Re: Office Development
4700 Eubank Blvd. NE
Traffic Circulation Layout
Architect's Stamp 10-25-22 (F21-D073)

The TCL submittal received 01-04-2023 is approved for Building Permit by Transportation. A copy of the stamped and signed plan will be needed for each of the building permit plans. Please keep the original to be used for certification of the site for final C.O. for Transportation.

January 9, 2023
Project: 4700 Eubank Blvd NE 8300 Palomas Ave NE
Subject: TCL Comment Responses

AS101a

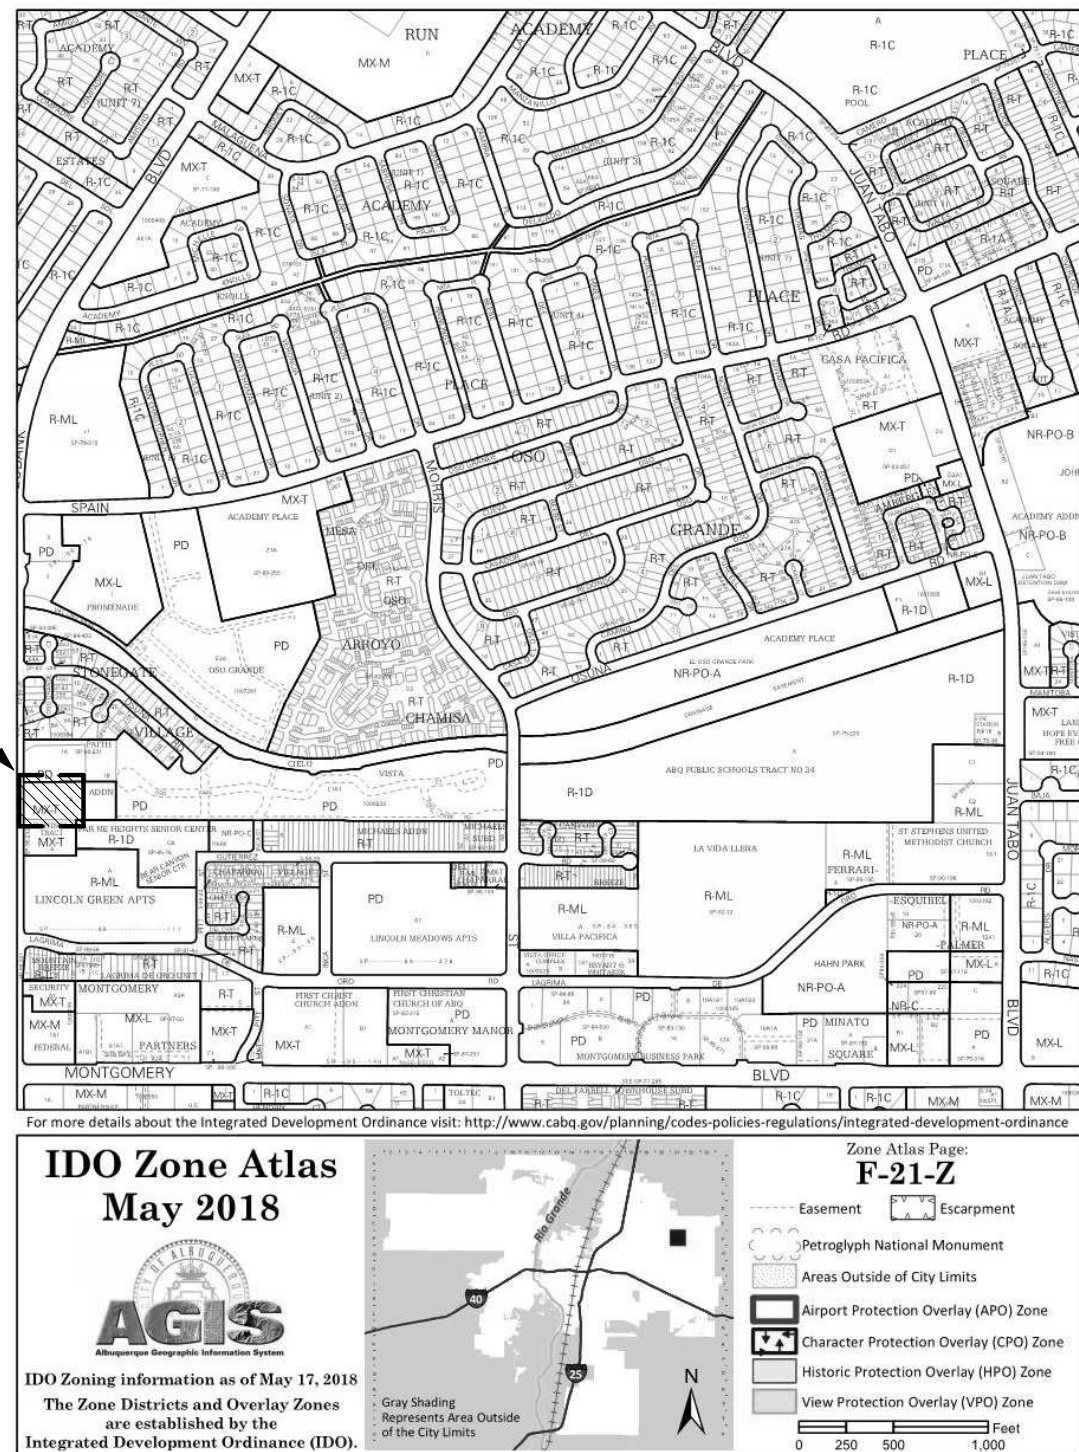
1. Show the clear sight triangle (11' X 11') on the site plan and it should start at the back of the sidewalk. .
 - a. The clear sight triangle has been added to sheet AS101a.
2. Show on the site plan the ADA pavement symbol on the ADA parking spaces at the south side of building 2.
 - a. The ADA pavement symbol is now indicated on the ADA parking spaces for building 2 on sheet AS101a.
3. Keynote 10: it appears the proposed ADA ramps will not be competent in this place. Suggestion, please refer to COA std dwg 2443, detail A- parallel curb ramp. See attached COA std dwg 2443 ADA ramp details.
 - a. The ADA ramps for building 1 and building 2 has been changed on sheet AS101a to reflect COA standard drawing 2443.
 - b. The ADA ramp detail on sheet AS102a has been changed to
